Staff Report

To: BOZAR
From: Jessie Earley, Town Planner III
Meeting Date: DRC, March 17, 2025
RE: 422 and 422 ½ Sopris Avenue, Final Review

PROJECT TITLE: Breuer Residence (422 Sopris Avenue)

SUMMARY: Consideration of the application of **John Andrew Breuer and Amy Padgett Breuer** to site a new single-family residence and accessory dwelling to be located at 422 and 422 ½ Sopris Avenue, Block 35, Lots 5-6 in the R1C zone. *Continued from the January 28, 2025 BOZAR meeting.*
(Ryan/Hadley)

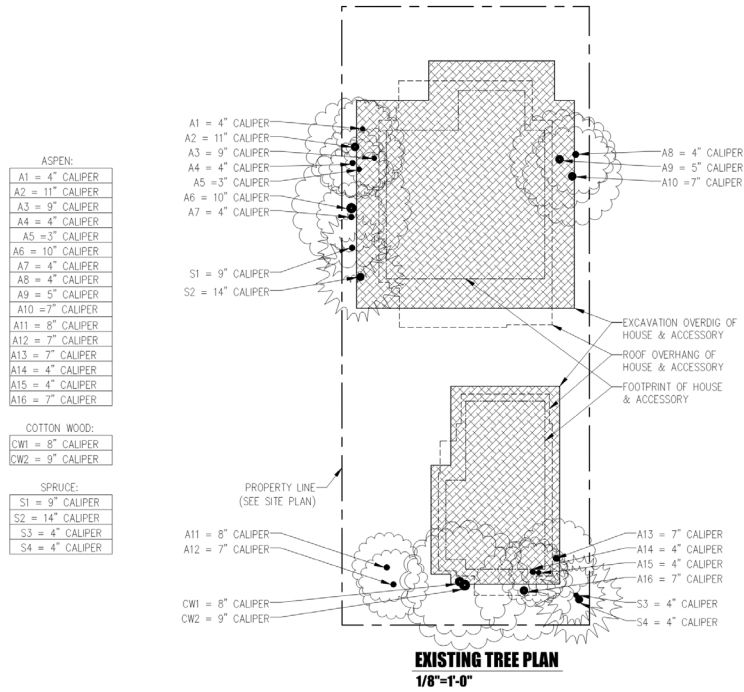
2.16 Substantial landscaping	The plan is fairly general. Provision of a final landscape plan can be required, if changes occur.	
2.18 Preservation of existing mature trees	<p>This site is heavily treed. There are smaller existing trees in the middle of the lot that will need to be removed for the placement of the home and accessory. These trees are all less than the caliper noted within the code 16-15-10. The applicant has provided a letter from an arborist clearly outlining the requirements of the site based upon the construction that is proposed. The applicant based upon this letter has provided a site plan showing the recommendations from the letter. Both are attached to the packet. Staff appreciates this information, as it better outlines what can be done for the health of the trees.</p> <p>Also, there are trees along the edges of the lot to the west (11) and east (3) and that are noted to be removed and replaced.</p> <p>There are six trees on the south that are proposed to be removed to ensure access to the new accessory dwelling. Two trees will remain.</p> <p>It appears that all trees that exist on the lot with the exception of the two spruce trees on the southeast corner will be removed.</p>	<p>12/9 DRC: Members asked for a more detailed plan for what trees would be removed. This has been provided.</p> <p>1/13 DRC: Members appreciated the tree plan. They asked for the number of trees in the mid lot area and size.</p> <p>The trees on the south were supported for removal due to access for the proposed ADU.</p> <p>The trees on the east and west would be a topic of conversation for the full Board.</p> <p>1/28 BOZAR: Members had concerns regarding the trees.</p> <p>3/17 DRC: Members asked for a site plan to show what the arborist letter was reviewing, which has</p>

arborist letter was reviewing, which has been provided.
2.16 a./ 2.20 Native plantings	<p>Sod is noted on the north portion of the property and on the east side of the structures. Generally, the GL supports use of native grasses. Discussion is encouraged.</p> <p>The applicant has mentioned in an email that they would be willing to provided native grass mix on the north side of the lot.</p>

been provided.

Proposed Site Plan (12/9/2024 DRC)

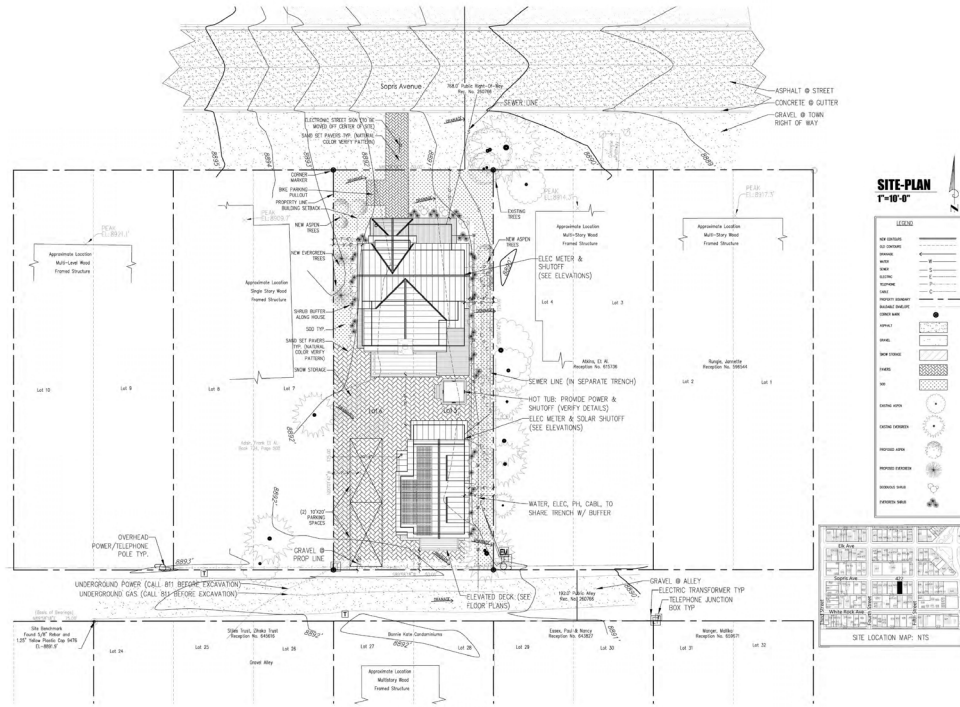
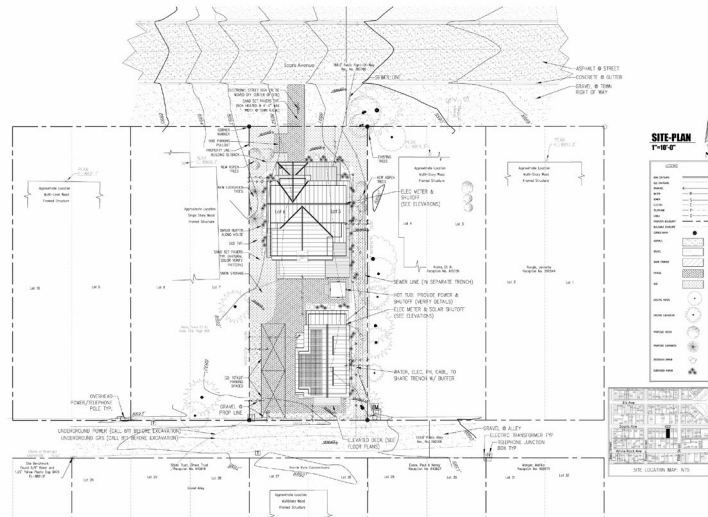
2.16 e Pervious materials	<p>There is a small area of gravel on the south side of the lot adjacent to the alley.</p> <p>The south portion of the lot and between buildings is called out as sand set pavers and was reduced from (2125.07 sf – 12/9 DRC) to (1286.35 sf -1/13 DRC) to (916.39 sf – 3/10 DRC). It is appreciated that the material is pervious.</p> <p>There is a walkway and bike parking pull out on the north side of the lot, which extends into the right of way that is also noted as sand set pavers (182.11 sf). The width of the sidewalk on the north has been revised and does not exceed 4' into the ROW and cannot be heated.</p>	<p>12/9 DRC: Members expressed concerns regarding the amount of hardscape on the south. This was revised.</p> <p>1/13 DRC: The revisions were more well received. However, there was still a concern from one member about the amount of hardscape proposed. This has been further reduced.</p> <p>1/28 BOZAR: The reduction of the hard scaped areas was supported.</p>

2.28 e & f Parking substrate	Parking spaces are noted as sand set pavers, which meet the intents of the GL. General support.	Support
(2.37-2.40)/ 16-17-40 Exterior Lighting	Proposed lighting appears to comply with night sky requirements. General support.	Support
Solar	There is solar proposed for the west roof face of the ADU, south, east and west gables of the primary building, which meets the intents of the GL.	Support
Utilities	<p>Wet and dry utilities have been included on the site plan. Water and sewer lines should not be located on the same side of the home (east), and the plans have been updated to separate these. It now shows wastewater on the west and water on the east.</p> <p>If a lift station is required, it would need to be included on the interior of the structure. This has been noted by the applicant.</p> <p>Adjacent rights of way are included to scale.</p>

- Site Plan:
 - Pavers further reduced by:
 - Adding gravel at the garage dripline.
 - Reducing the South West patio & adding grass.
 - Removing the pavers under the Hot Tub & surrounding its concrete pad with grass.
 - Limited the entire length of the North walkway to 4'-0" wide.
 - Additional Evergreen & Aspen trees have been added to the South West yard, formerly the patio.
 - Drywell Added.
 - Sewer & Water Lines Separated.
 - Two water lines shown by code.
 - Right Of Way dimensions and additional Building Departments notes added, see Astrid's initial review response.

Proposed Streetscape – 1/28 BOZAR

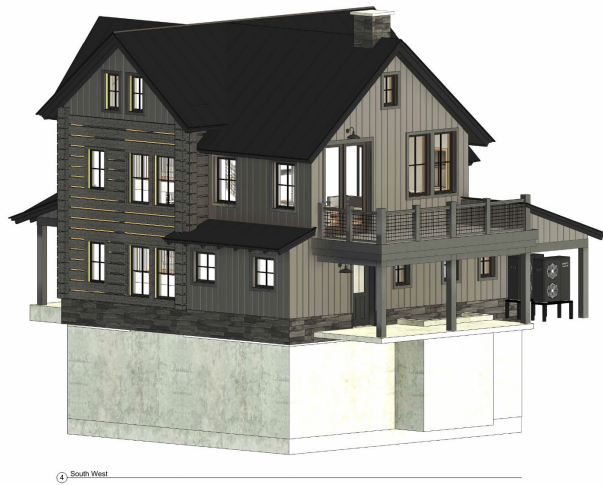
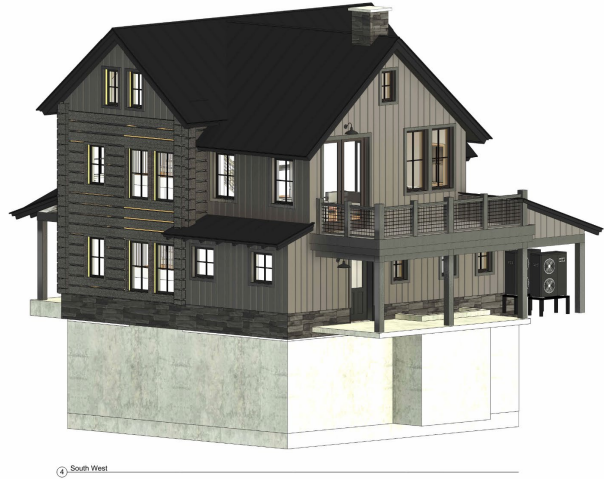
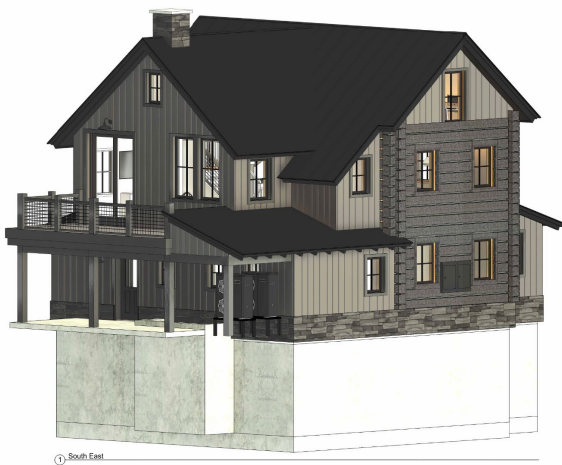
4.26 Excessive Dissimilarity	Discussion is encouraged to determine if what is proposed is a contemporary interpretation and variety or if the proposal is excessively dissimilar. An updated streetscape has been provided to assess if the revised forms better relate to the historic RIC zone surrounding the property. 3D massing for streetscapes have been provided for other projects, which may be necessary. This building is at the height maximum of 28' and below the width maximum of 32' per zoning requirements. The design goals of this zone district encourage infill to help preserve the character of the existing buildings. Discussion is encouraged to determine if revisions to the plans have been successful in better conforming the forms of this structure to the surrounding RIC zone. The applicant has removed the cricket, revised windows and reduced the height of the gable module by 12" from the previous application and finally, carried the previously cantilevered gable to the ground to emulated a more historic form, rather	<p>12/9/ DRC: Streetscape was encouraged to help evaluate this.</p> <p>1/13 DRC: A streetscape was provided for the DRC meeting. There was a lot of discussion about neighborhood context and the massing of this structure. One member could find support, as drawn. However, the other member had concerns regarding the proposed massing.</p> <p>The number of trees proposed for removal was discussed. It was asked if the trees could be relocated onsite and Matt Brezonik, contractor, didn't think so.</p> <p>1/28 BOZAR: Members were concerned regarding the forms of the building per GL, as seen from the north/street side due to the contemporary nature.</p> <p>1/28 BOZAR: Members had concerns regarding the trees.</p> <p>3/10 DRC: Members appreciated the responsiveness from the applicants for</p>

GL	Staff Analysis	DRC Recommendation
4.32-4.33	<p>Consideration of whether the forms better achieve relationships with historic buildings are in GL 4.32-4.34. The 3D drawings are helpful in the review. The simplification of the gable module perpendicular to the street, including carrying the module to the ground, and modification of the fenestration has helped to simplify this elevation.</p> <p>GL 4.32 conveys that new infill construction should relate with the predominate scale of historic neighborhoods. An updated streetscape has been provided to assess if the revised forms better relate to the historic RIC zone surrounding the property. 3D massing for streetscapes have been provided for other projects, which may be necessary. This building is at the height maximum of 28' and below the width maximum of 32' per zoning requirements. The design goals of this zone district encourage infill to help preserve the character of the existing buildings. Discussion is encouraged to determine if revisions to the plans have been successful in better conforming the forms of this structure to the surrounding RIC zone. The applicant has removed the cricket, revised windows and reduced the height of the gable module by 12" from the previous application and finally, carried the previously cantilevered gable to the ground to emulated a more historic form, rather than contemporary.</p> <p>Per GL 4.33, a diversity of forms is encouraged. Many of the homes on this south side of the block have a gable facing the street. The gable running parallel to the street varies this appearance.</p>	<p>12/9 DRC: Members requested a streetscape to better evaluate mass/scale and form as it relates to the context of the neighborhood.</p> <p>1/13 DRC: Members had concerns regarding mass/scale/form as seen from the street per GL 4.32 a. One member felt that they could support, as drawn, but gave a suggestion to revise materials to help make the building less complicated. Siding materials have been revised in color.</p> <p>1/28 BOZAR: Members were concerned regarding the forms of the building per GL, as seen from the north/street side due to the contemporary nature.</p> <p>3/10 DRC: Members appreciated the responsiveness from the applicants for removing the front gable. However they felt that this change made the building look more massive and therefore did not fit with mass/scale/form GL It was discussed that the front gable helped to break up the mass, but revisions were encouraged. The applicant has provided revised drawings.</p> <p>3/17 DRC: Members asked if the gable module could continue to the ground instead of cantilevering, which has been provided.</p>

GL	Staff Analysis	DRC Recommendation
4.35	<p>Discussion of whether overall building forms appear as a product of their own time while relating with historic forms seen in town is encouraged. An updated streetscape has been provided to assess this. 3D massing for streetscapes have been provided for other projects, which may be necessary. The applicant has removed the cricket, revised windows and reduced the height of the gable module by 12” from the previous application and finally, carried the previously cantilevered gable to the ground to emulate a more historic form, rather than contemporary.</p> <p>This building is distinguishable as new.</p>	<p>12/9 DRC: Members requested a streetscape to better evaluate mass/scale and form as it relates to the context of the neighborhood.</p> <p>1/13 DRC: Members evaluated the streetscape provided. There were some concerns that some of the details of the proposed primary building were contemporary for this infill within a core zone. Details such as: stone foundation cover, differing siding color treatments, window to wall ratio.</p> <p>3/10 DRC: Members appreciated the responsiveness from the applicants for removing the front gable. However they felt that this change made the building look more massive and therefore did not fit with mass/scale/form GL It was</p>

- Streetscape: Updated to reflect the below revisions to the primary building.
- House Design:

Front porch – 1/28/2025 BOZAR

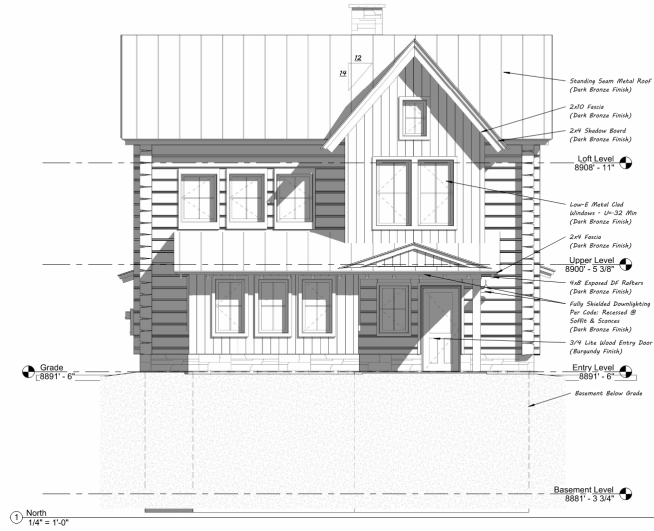
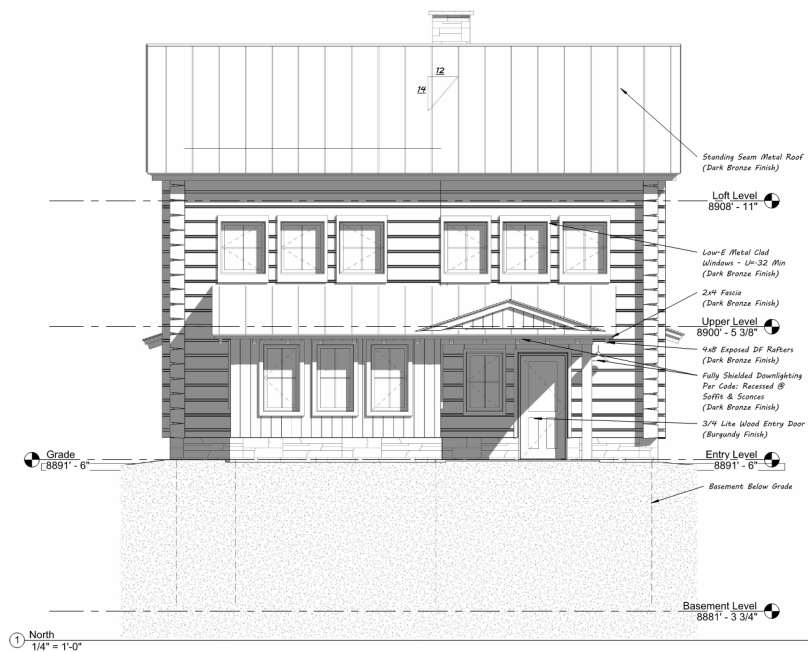
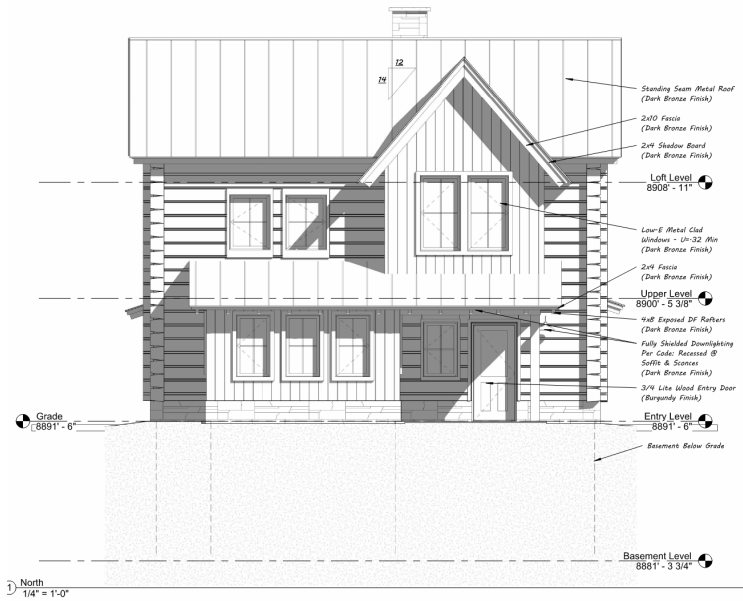
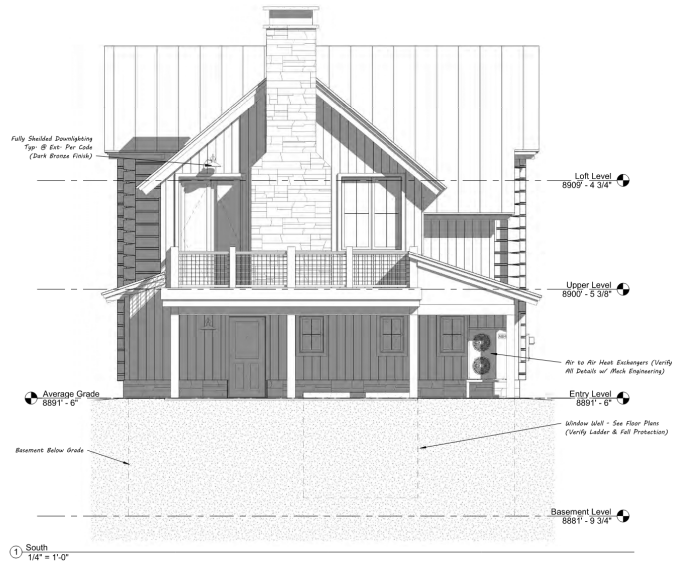
<p>discussed that the front gable helped to break up the mass, but revisions were encouraged. The applicant has provided revised drawings.</p> <p>3/17 DRC: Members asked if the gable module could continue down to the ground, which has been provided in revised drawings.</p>

GL	Staff Analysis	DRC Recommendation
4.49/5.118 Primary entrance porch	These GL encourage clearly defining the entry, which is done in many cases with a porch as seen on many historic buildings and also on this building. General support. The cricket was removed from this porch to help simplify the elevation.	Support
4.50 Mix of porch sizes	The front porch is 8'x10'6", which meets the intents of this GL.	Support
4.51 Rear entry porch	The porch on the rear is simpler with the shed than the front porch, as asked for in GL 4.51.	Support

- North: The bump out from the upper level at the dining area now continues down to the entry porch. The applicants feel that this better balances the top & bottom while simplifying the overall massing. Although it adds to the sq ft of the house it removes just enough of the porch to conform with the maximum allowable sq ft.
- South: High gable window removed, stovepipe to become interior chimney.

Front elevation fenestration – 3/17/2025 DRC

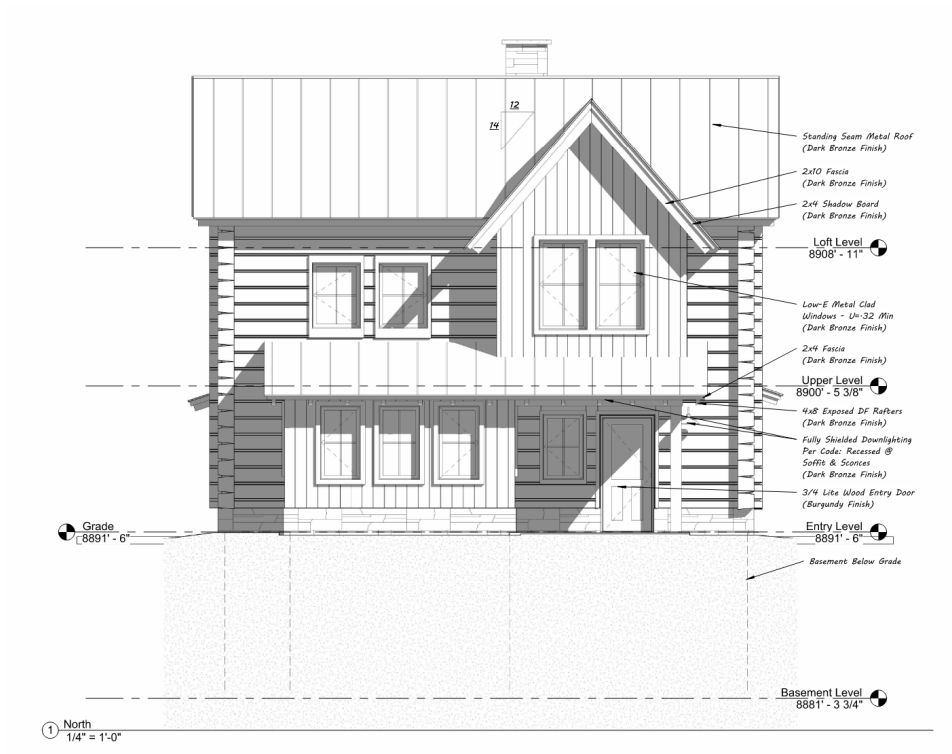
GL	Staff Analysis	DRC Recommendation
4.53 Window to wall ratio	Window to wall ratios along the front (south) elevation proposes 119.99 sf of glazing/659.57 sf wall space, which is	12/9 DRC: Members supported the overall window to wall ratio.

<p>18.2% window to wall. This is relational to other applications.</p> <p>On the front elevation, first floor there are four single windows and door glazing (48.48 sf). There are two single windows and a two pack on the second floor (55.9 sf), which appears to conflict with the intents of 4.53 b, as there is more glazing on the upper floor. However, the glazing on the second floor was reduced and it now is closer to being balanced than it was before.</p> <p>On the west elevation there are four single windows and a two pack on the first floor and on the second floor there are three single windows and a two pack. There are two windows in the gable.</p> <p>On the east elevation, there are four single windows on the first floor. The second floor has four single windows. The gable has one window</p> <p>The north elevation proposes three single windows and door glazing on the first floor and a two pack and full light French doors on the second floor with a single window in the gable.</p>	<p>However, members voiced concern about the amount of glazing on the first floor versus the second floor in that it was top heavy.</p> <p>1/28 BOZAR: Windows were not discussed in detail due to the requested changes in form.</p>

12" to the corner per GL 4.57 a.	
4.58 Groupings of 2 or more windows	There is 6" of trim between two packs of windows on the North, South and West elevations, as encouraged in this GL. These windows cannot be mulled. The three pack on the front was revised to a two pack.	12/9 DRC: Members asked for 3.5" of trim for 2 packs, which has been provided and separation of three packs. This has also been provided.
4.59 Window and door trim	2"x4" wood. General support.	Support
4.63 Window wells	Window well on rear elevation under the deck can be supported.	Support

Option 1: 3/17/2025 DRC

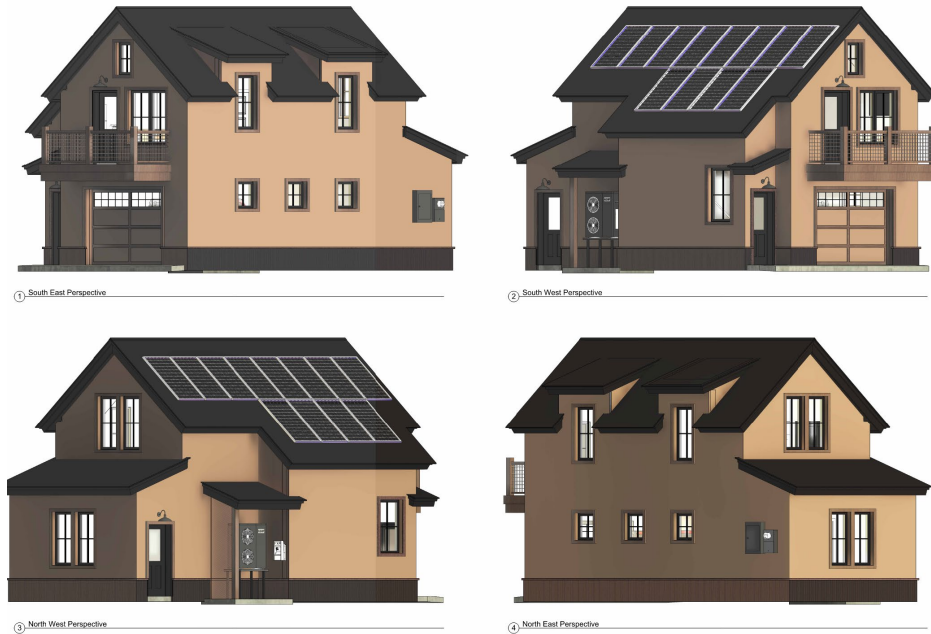
GL	Staff Analysis	DRC Recommendation
4.46 Dormers in new construction	There are two shed roof elements proposed for the east elevation, as was proposed in the original design. Discussion is needed to determine if the Board considers this a dormer. If so, it is a shed dormer, which is supported by this GL.	<p>1/13 DRC: Members expressed that this is a dormer.</p> <p>1/28 BOZAR: Members expressed that the large element was a dormer and needed to meet the GL.</p> <p>3/10 DRC: Members expressed support for the dormers as proposed. However they asked that the applicants provide justification. This has been provided.</p> <p>3/17 DRC: Members could support as drawn.</p>

4.47 Dormers	<p>The two shed dormers steps down 1'10" from the ridge of the garage module and achieves subordination.</p> <p>a. As proposed the two occupy 29.7% of the roof.</p> <p>b. The dormers are lower than the ridge. There is not a section of roof beneath either, as required in core zones.</p> <p>c. As proposed the two occupy 29.7% of the roof.</p> <p>d. The proposed shed dormers extend past the middle third on both the south and north sides.</p> <p>e. Met.</p>	<p>1/13 DRC: Members expressed that this was a dormer due to the language in 4.47 b. requiring it in core zones.</p> <p>With that in mind, it doesn't comply with GL noted.</p> <p>1/28 BOZAR: Members expressed that the large element was a dormer and needed to meet the GL.</p> <p>3/10 DRC: Members expressed support for the dormers as proposed. However they asked that the applicants provide justification. This has been provided.</p>

4.87 Dormers on ADU	<p>4.87 b. See above.</p> <p>c. Both break the eave line and aren't less than 3' than 24'.</p> <p>d. NA</p>	<p>1/28 BOZAR: Members expressed that the large element was a dormer and needed to meet the GL.</p> <p>3/17 DRC: Members could support as drawn.</p>

- Garage(s):
 - The applicants are showing three different roof proposals for the accessory dwelling to discuss.
 - (X.1) This garage displays what the applicants feel is the best option in terms of habitability of the ADU. They are showing two "Roof Elements" each with 4'-0" tall windows allowing for maximum light, ventilation, views & egress.

- (X.2) This garage displays what the applicant's feel guidelines state as allowable. They are showing two "Dormers" each with the higher roof continuing through the exterior wall & thereby limiting the window size. This design to the applicant feels unbalanced with the expanse of wall below the roof & above the lower windows. Additionally these dormers get pushed up to the ridge, against the guidelines, to allow even a small window with very limited sky views & light.

- (X.3) This garage has no dormers or roof elements. The applicants feel that it is the most unlivable.
- Site Plan: Matt has engaged an Arborist & they will be producing a tree viability report shortly.
